Development Review Committee Comments | 8/30/2022  
Case PLAT22-0026  
Shady Grove Addition (8340 Shady Grove Road)

**WRITTEN STATEMENT OF CONDITIONS**

PRELIMINARY PLAT  
SHADY GROVE  
NORTH RICHLAND HILLS, TEXAS

C-0.2

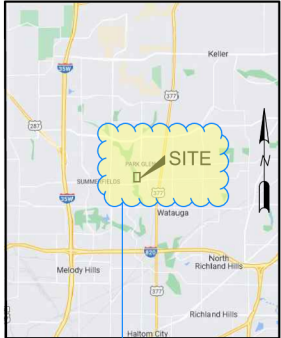
- The side and rear building line setbacks can be removed from the drawing. Show only the front building line setback and setbacks adjacent to side street frontages.
- Add a 7.5-foot wide utility easement adjacent to the rear property line of all lots.
- Add a 2.5-foot screening wall easement on the rear of lots adjacent to Shady Grove Road.

Dimensions should be 15' x 70'

Sight Visibility Triangle  
15' X 75'  
May need simple SV triangle at the intersections throughout development

Shady Grove Road is classified as a C2U Minor Collector street on the Transportation Plan. A C2U roadway requires an ultimate right-of-way of 60 feet. Verify the existing right-of-way with established corner monuments on the west side of the street. Right-of-way dedication may be required depending on the width of the existing right-of-way

Increase the line weight of the property boundary line so that the property boundary is differentiated from the other lines on the drawing.

Revise the location map to indicate the subject property

Will there be any rear yard UE?  
Screening Wall Easement along Shady Grove?

Status of Flood Study? Based on the proposed reclamation, drainage easements could change throughout this site.

Note needs to be added to all lots with floodway that building permits cannot be pulled until a LOMR has been submitted.

Need a 10-foot erosion control set back from the top of the slope of the earthened channel.

Where are the Flood Notes?

Add a title block to the plat that includes the following information

2.5 DUA

Is this proposed to be abandoned? D.E. going through lots. won't allow homes to be built.
